ORDINANCE NO. 29164

An ordinance amending Chapter 57, "Dallas One-and Two-Family Dwelling Code," of the Dallas City Code, as amended; adopting with certain changes the 2012 Edition of the International Residential Code of the International Code Council, Inc.; regulating the construction, enlargement, alteration, repair, demolition, use, and maintenance of construction, plumbing, mechanical, and electrical work in the city on one- and two-family dwellings; providing a penalty not to exceed \$2,000; providing a saving clause; providing a severability clause; and providing an effective date.

SECTION 1. That Chapter 57, "Dallas One- and Two-Family Dwelling Code," of the Dallas City Code, as amended, is amended by adopting the 2012 Edition of the International Residential Code of the International Code Council, Inc. (which is attached as Exhibit A and made a part of this ordinance), with the following amendments:

"FIGURE R602.6.1 TOP PLATE FRAMING TO ACCOMMODATE PIPING

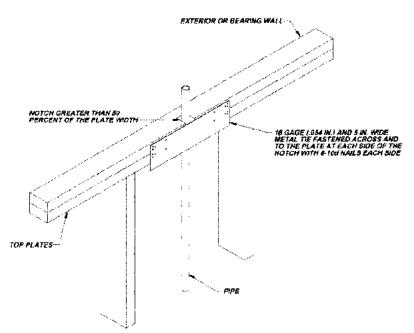
43. Figure R602.6.1, "Top Plate Framing to Accommodate Piping," of Subsection R602.6, "Drilling and Notching of Studs," of Section R602, "Wood Wall Framing," of Chapter 6, "Wall Construction," of the 2012 International Residential Code is deleted and replaced with a new Figure R602.6.1, "Top Plate Framing to Accommodate Piping," to read as follows:

"R602.6.1 Drilling and notching of top plate. When piping or ductwork is placed in or partly in an exterior wall or interior load-bearing wall, necessitating cutting, drilling or notching of the top plate by more than 50 percent of its width, a galvanized metal tie not less than 0.054 inch thick (1.37 mm) (16 ga) and 5 [4½] inches (127 [38] mm) wide shall be fastened across and to the plate at each side of the opening with not less than eight 10d (0.148 inch diameter) having a minimum length of 1½ inches (38 mm) at each side or equivalent. Fasteners will be offset to prevent splitting of the top plate material. The metal tie must extend a minimum of 6 inches past the opening. See Figure R602.6.1.

Exception: When the entire side of the wall with the notch or cut is covered by wood structural panel sheathing."
